RE: **PUBLIC** Comments of the Minnesota Department of Commerce
Docket No. E002/M-25-142

In the Matter of Xcel Energy's 2025 Integrated Distribution Plan.

Xcel Energy's (Xcel or the Company) Integrated Distribution Plan (IDP) was filed on October 31, 2025. Xcel's Transportation Electrification Plan was filed concurrently.

The Department recommends the Commission accept Xcel's IDP with additional requirements and is available to answer any questions the Minnesota Public Utilities Commission may have.

Figure 34: Xcel Spending by Budget Category and Planning Division

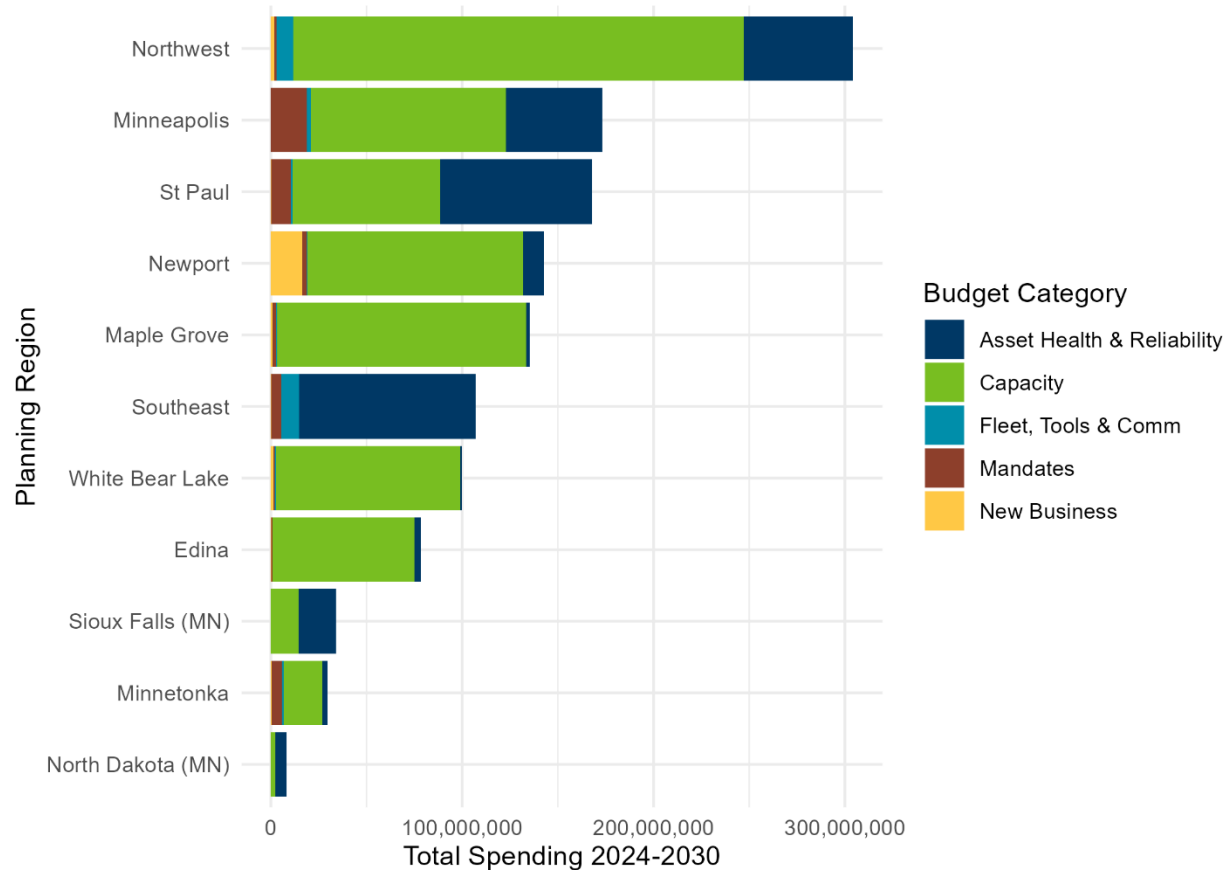
The variation in forecasted distribution spending across PD shown above—particularly the differing balance between asset health-driven investments and capacity-driven investments—cannot be explained by population growth alone.
